SERVICE BULLETIN

APPLICABILITY: 2020-23MY Outback & Legacy With 2.4L DIT
 2019-23MY Ascent
 2022-23MY WRX

NUMBER: 09-106-23R

SUBJECT: Exhaust Pipe Front (EPF) Design Change

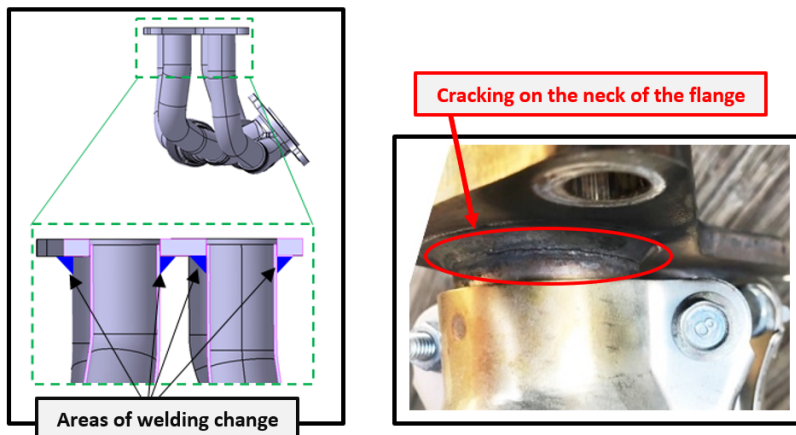
This bulletin announces design changes made to the Exhaust Pipe Front (EPF) to address concerns of rattle-type or fluttering sounds coming from the undercarriage during acceleration caused by cracking in the EPF. A welding material with enhanced durability has been incorporated into the production of the EPF. If the condition described is confirmed, the EPF should be inspected and if determined necessary, replaced.
